TECHNICAL REPORT

AMENDMENT 1

Low-voltage fuses – Part 5: Guidance for the application of low-voltage fuses

This amendment corrects and adds to IEC TR 60269-5 published in 2014. This edition constitutes a technical revision.

Figures 17 to 19 show examples of inverters of voltage source type.

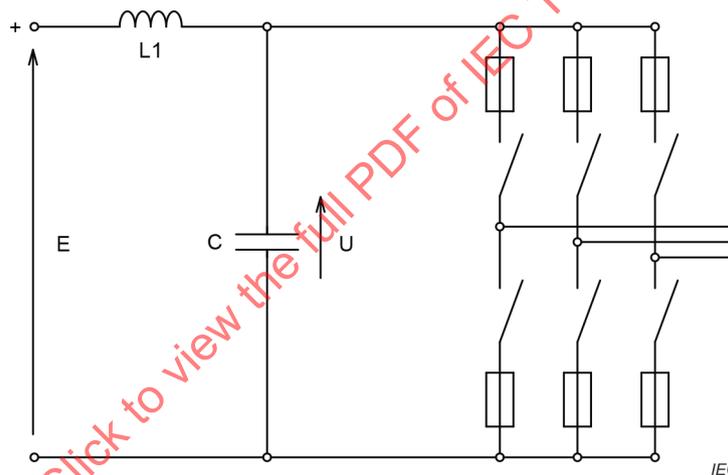
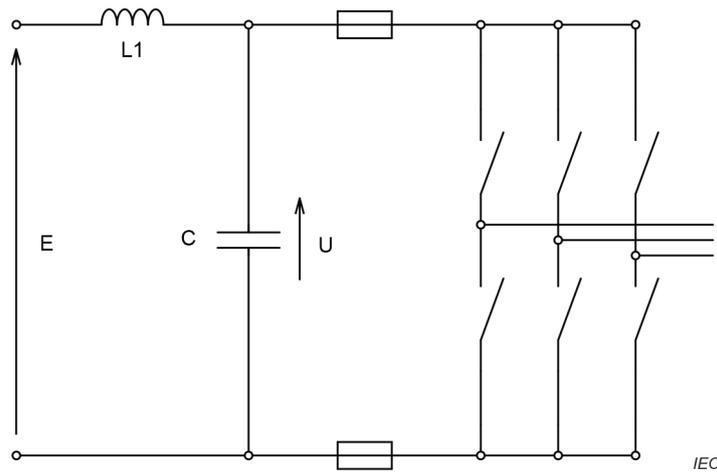
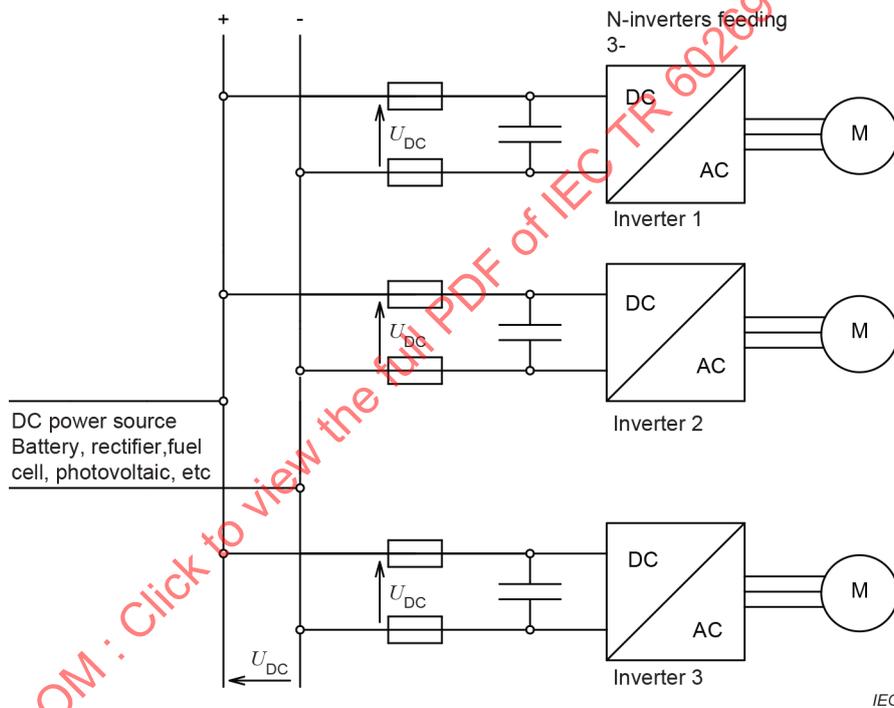
Add, at the end of Clause 15, the following new subclauses:

15.2 Fuse application with inverters

- fuses in the arms of the inverter (Figure 17)
- fuses in the DC loop of the inverter (Figure 18): fuse current rating is $\sqrt{3}$ times the current rating of the fuse in the arms
- fuses in the DC feeder (Figure 19): between the capacitor and rectifier
- (or another kind of DC power supply)

It is possible to combine Figure 19 and Figure 17 or Figure 19 with Figure 18.

Figure 20 – Capacitor discharge

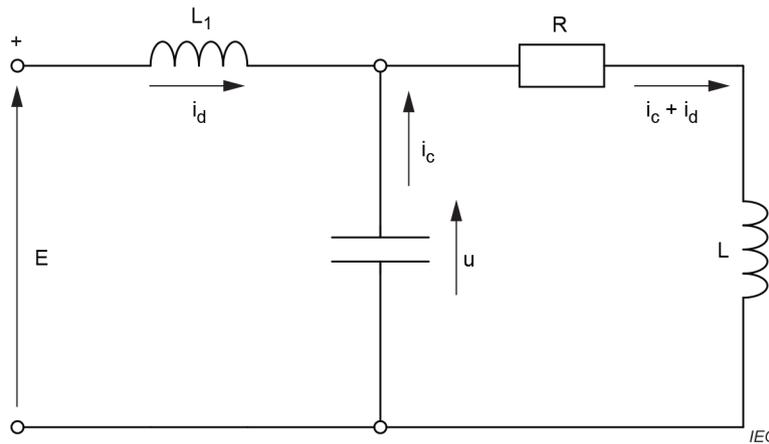
The fuse-link will operate very quickly as the di/dt is generally very high because of the very low value of the inductance L_1 (see Figure 20).

When an IGBT or a GTO fails the capacitor is short-circuited and the fuse is protecting a circuit as described in Figure 20.

Figure 21 – Voltage across the capacitor

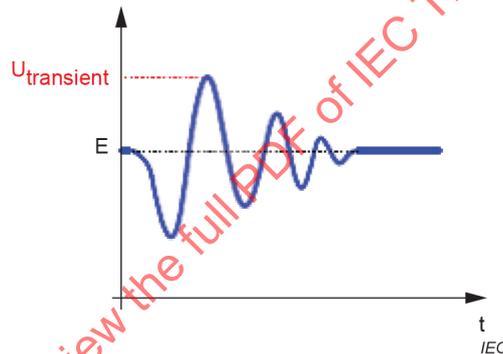
Just after the arc extinction, there is a transient phenomenon during the recharge of the capacitor by the power source producing an over voltage across the capacitor, the peak value of which is $U_{transient}$. This value is significantly above the initial value E (Figure 21).

Assuming there is no resistance in the circuit and assuming the capacitor has been fully discharged, the maximum theoretical value of this transient over-voltage is 2 E.

The realistic value is: $U_{transient} = 1,75 E$

Figure 22 – Inductance of the circuit

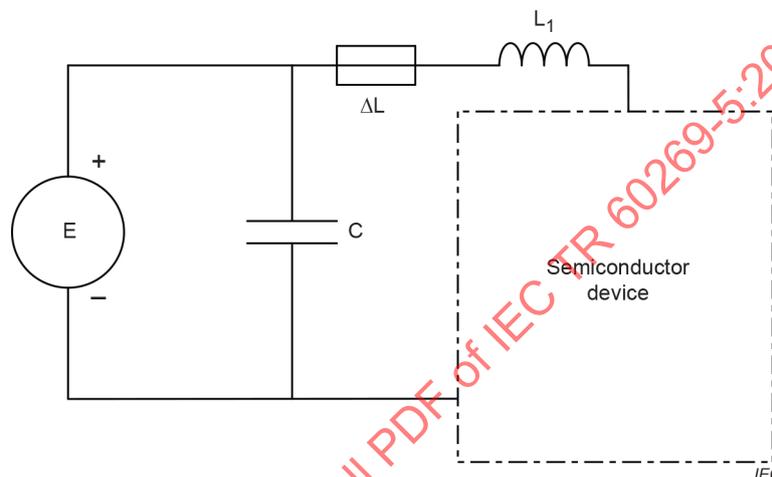
The L value of a circuit inductance depends mainly on the shape and length of the circuit. When the fuse is introduced into the circuit, it changes the length and the shape of that the circuit. Consequently the inductance L of the circuit becomes $L + \Delta L$ (Figure 22).

ΔL is not an inductance located inside the fuse having a constant value. Fuse manufacturers measured ΔL of several fuses with the circuit in Figure 22. The value of the circuit with fuse and without fuse is obtained by measuring the di/dt when the circuit is closed.

For these measurements the fuse is replaced by a copper bar in order to minimize the change of length of the circuit. The ΔL value drastically decreases when the body of the fuse is flat.
